# UNITED STATES PATENT AND TRADEMARK OFFICE

APPLICATION NO.	FILING DATE	FIRST NAMED INVENTOR	ATTORNEY DOCKET NO.	CONFIRMATION NO.
10/733,124	12/11/2003	Marc Bodet	056982/00037	7890

**Office Action Summary**

FIGURE A

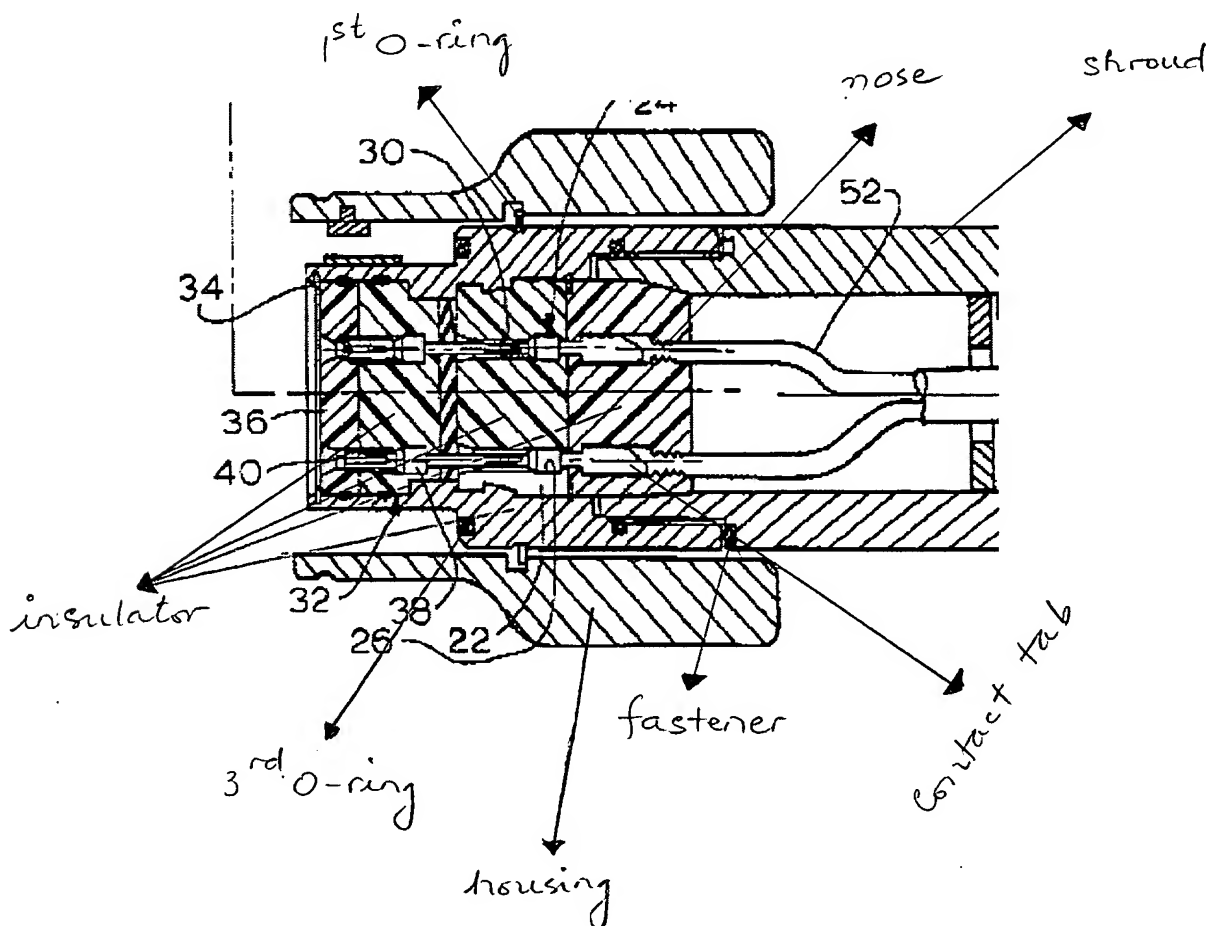
Regarding claim 4, Gerow, figure 2 shows a pressure-tight contact device for enabling an electrical connection to an electrical device housed in a pressure-tight housing, the contact device comprising an insulator (a FIGURE A below) extending through said housing (the FIGURE A below), at least one contact pin (38) extending through the insulator, a first O-ring seal (the FIGURE A below) for sealing the insulator relative to the housing, a connector shell (20) of insulating material positioned on the insulator and affixed to the insulator, the connector shell including a shroud (the FIGURE A below) and a terminal socket (not labeled) for receiving a connecting cable (50), at least one contact tab (30, 24 and the FIGURE A below) mounted in the connector shell, the at least one contact pin elastically and electrically connected to the at least one contact tab, a third O-ring seal (the FIGURE A below) for sealing the connector shell relative to the insulator, and at least one fastener (the FIGURE A below) for affixing the connector shell to the insulator, the at least one contact tab and the shroud forming the terminal socket for mating with a connector member of the connecting cable.

Regarding claim 5, Gerow shows the contact pin including at least one tip arranged and constructed to engage at least one opening (a front end of 30) defined in the contact tab.

Regarding claim 8, Gerow shows nose member (the FIGURE A below) for positioning the contact tab in the connector shell (since 24 is a crimp terminal).
